Request for Additional Information No. 30, Revision 0

U. S. EPR Standard Design Certification

AREVA NP Inc.

**SRP Section: 15.06.05 – Loss of Coolant Accidents Resulting From Spectrum of
Postulated Piping Breaks Within the Reactor Coolant Pressure Boundary**

Figure 15.06.05-16-10—Core Liquid level

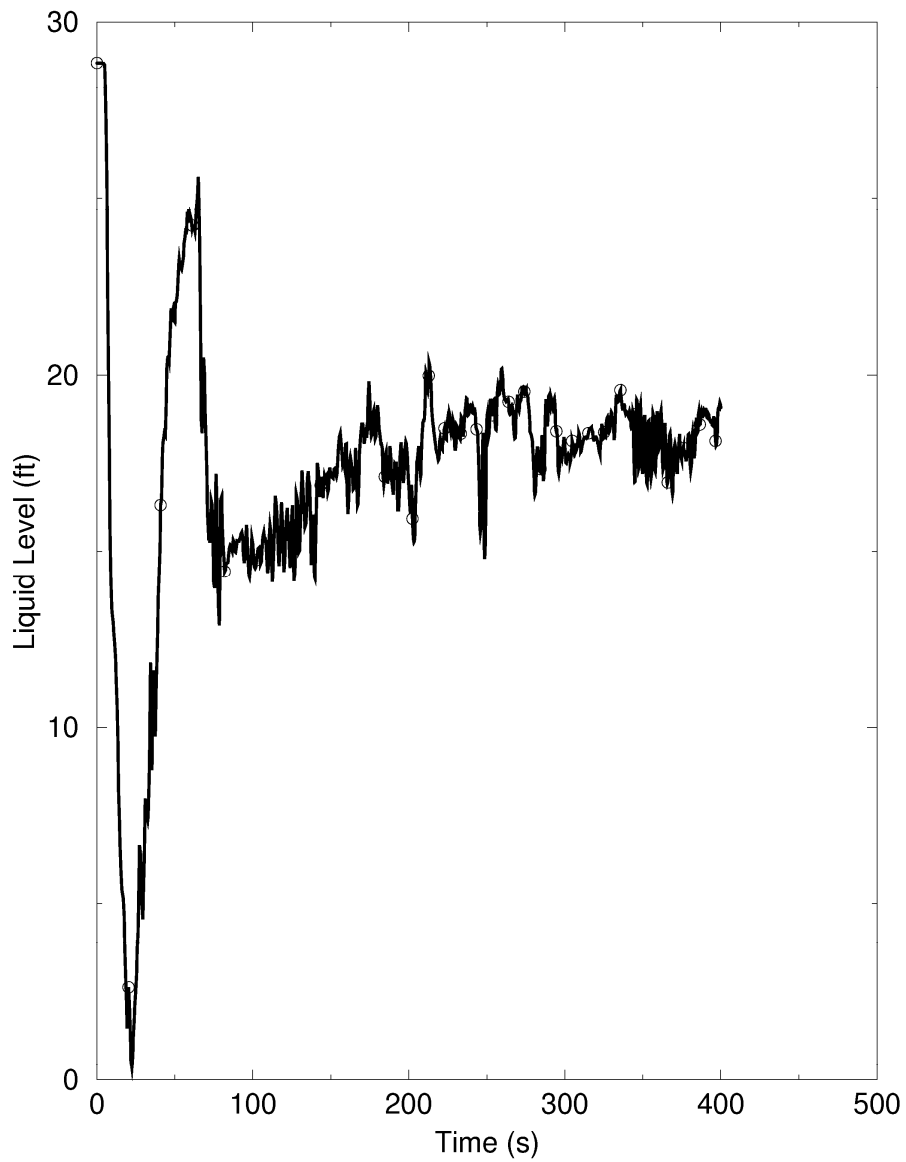
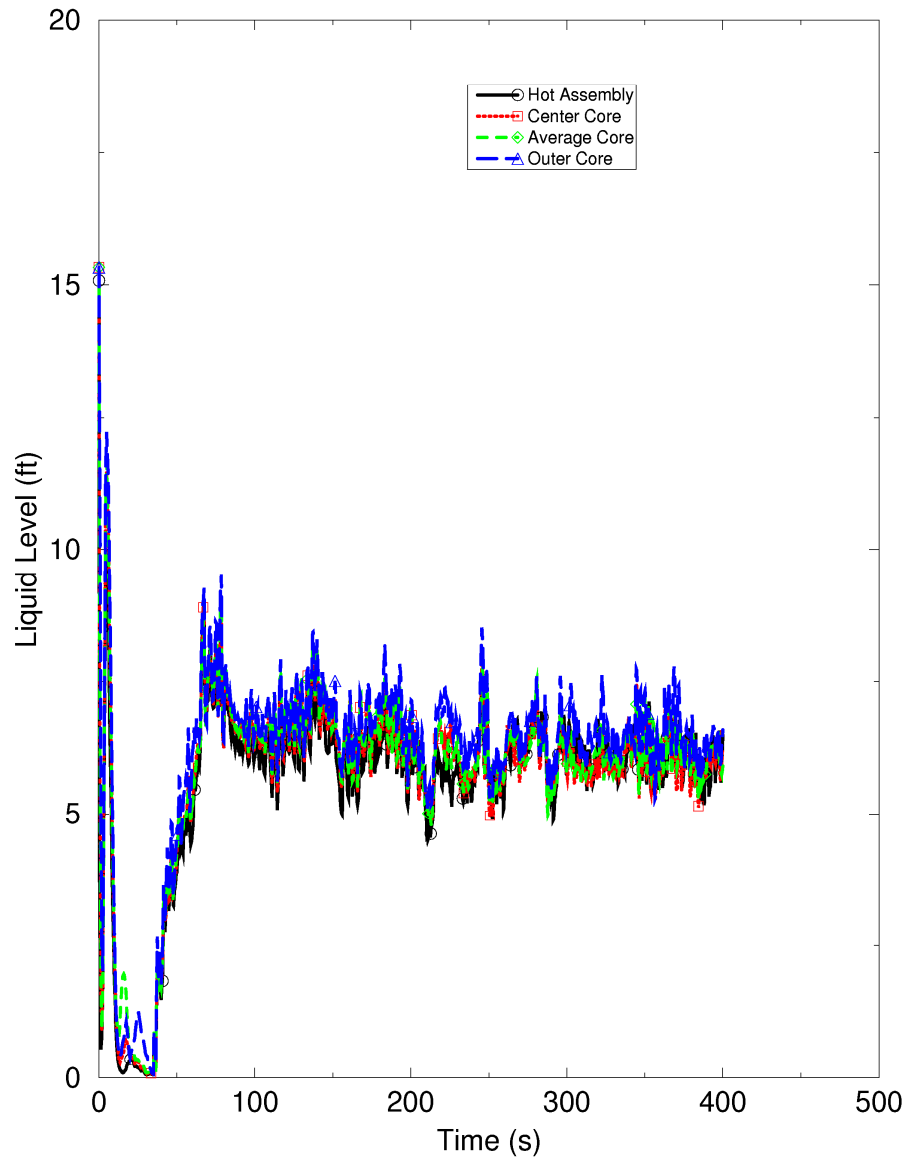
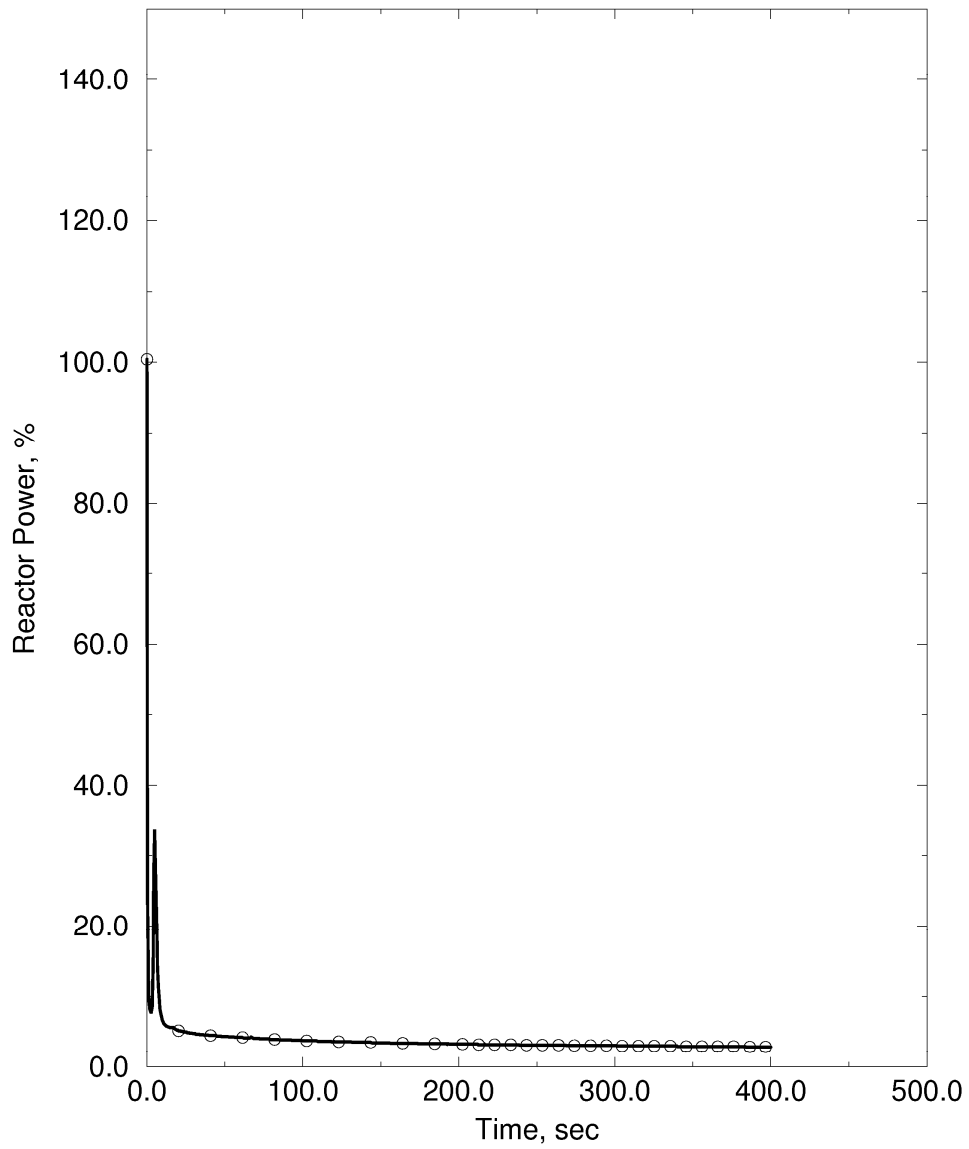
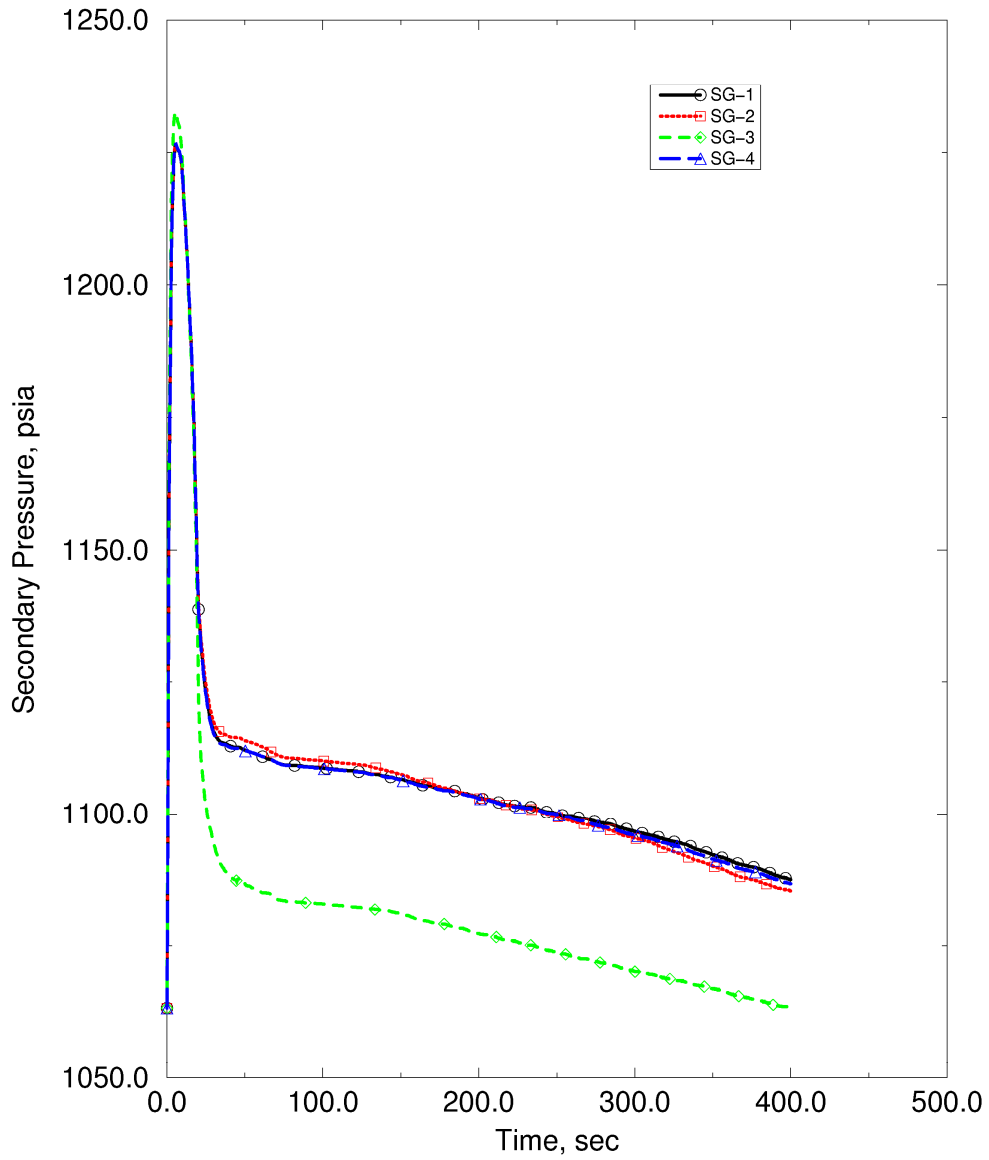
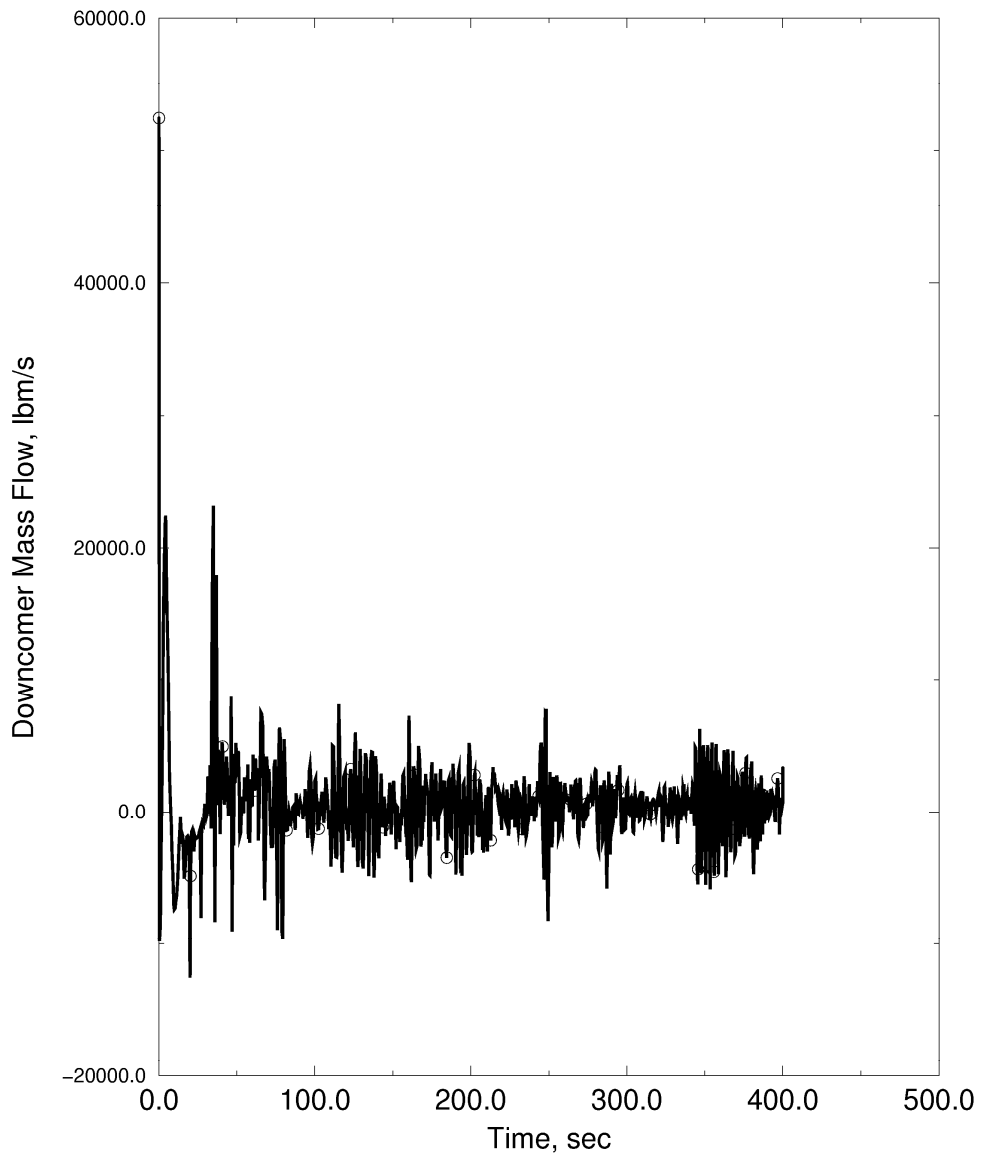
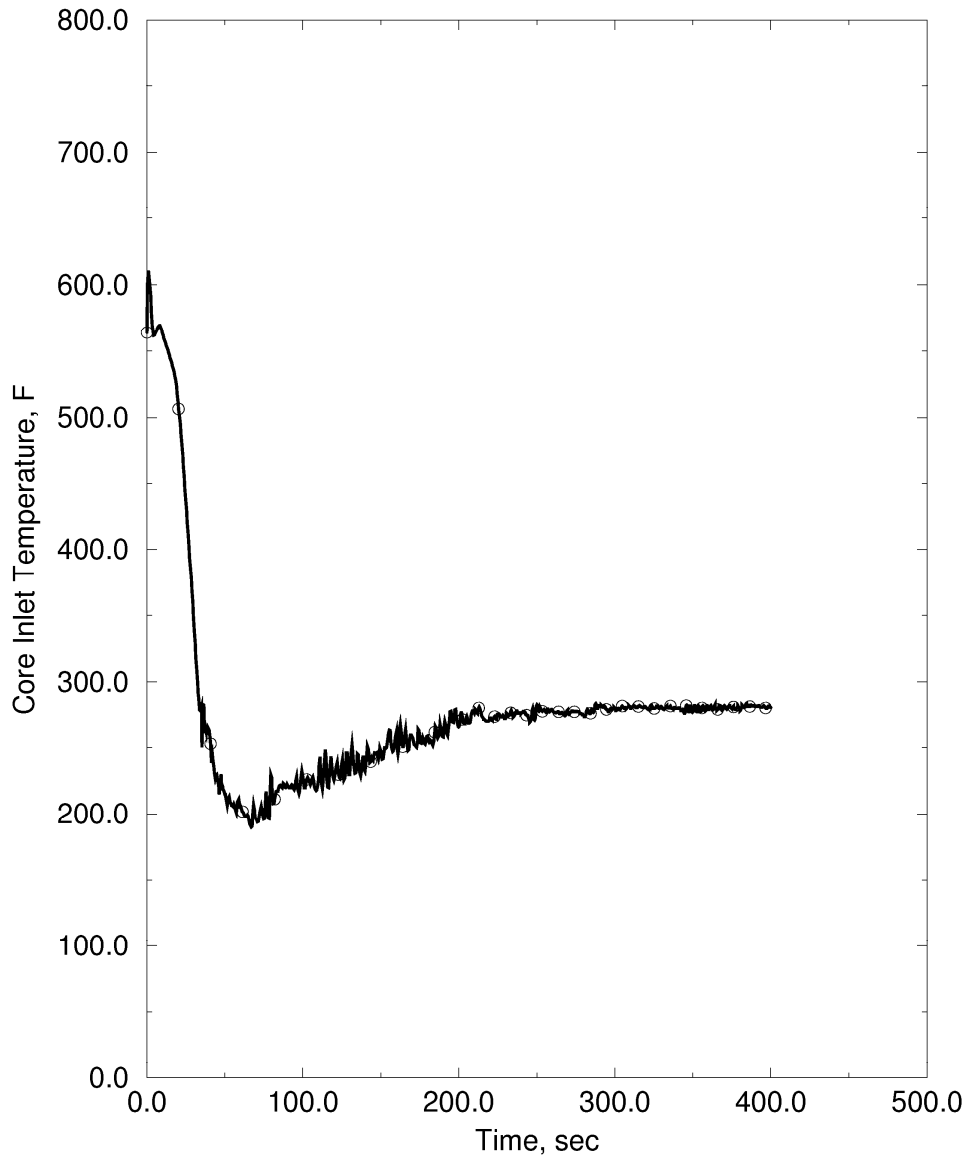
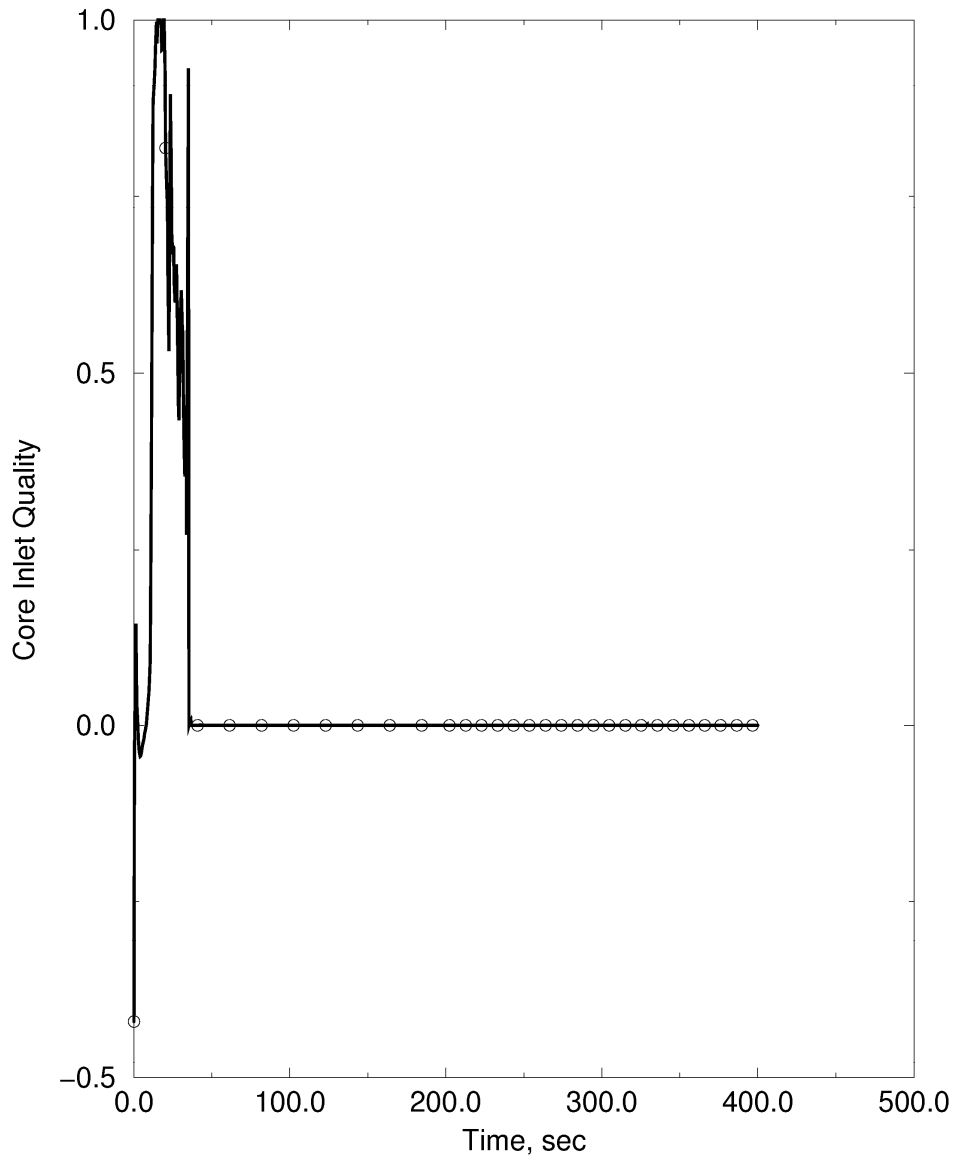
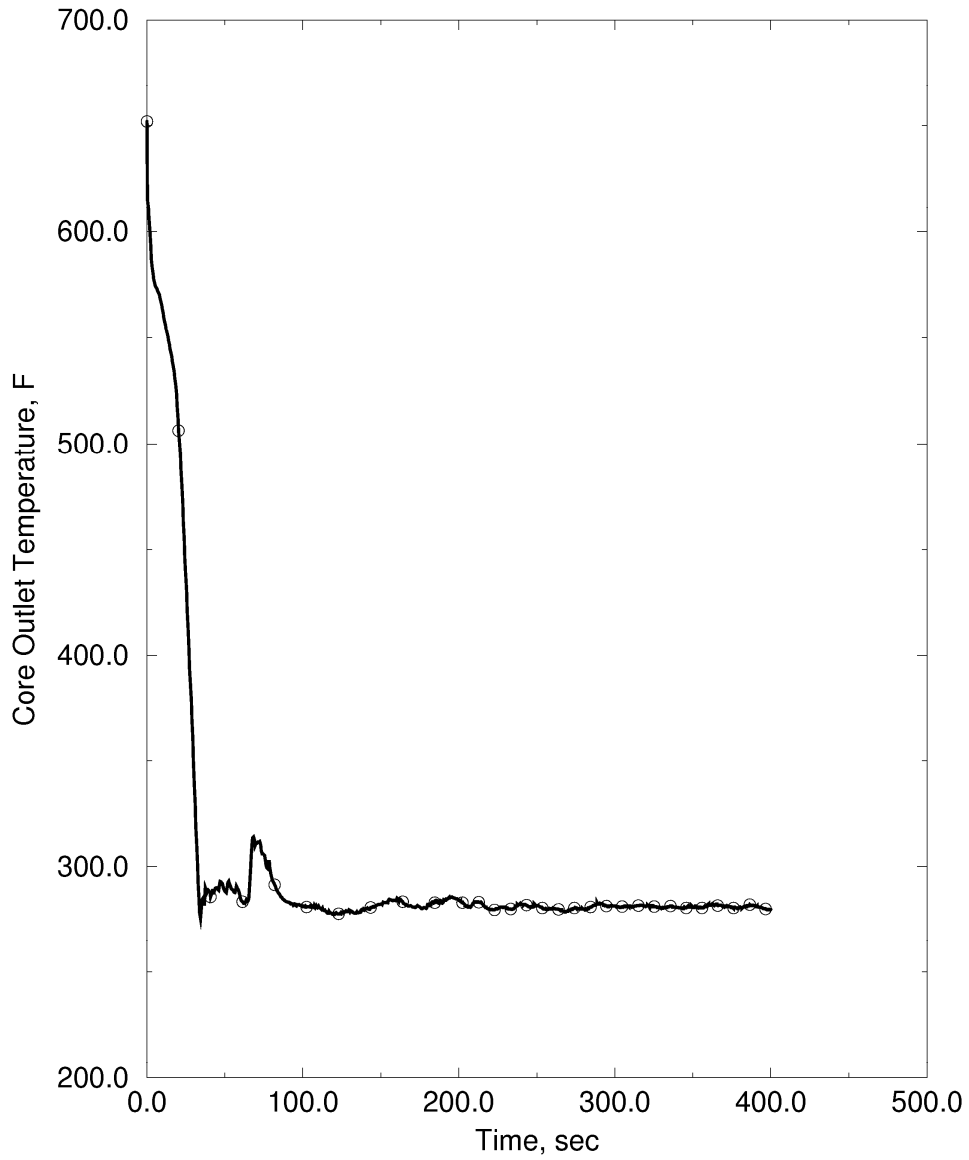
Plotted information has only been provided for the equilibrium cycle case. Please provide a set of plots similar to FSAR Figures 15.6-27 through 15.6-50 for the limiting PCT initial cycle case.

The requested figures are provided.
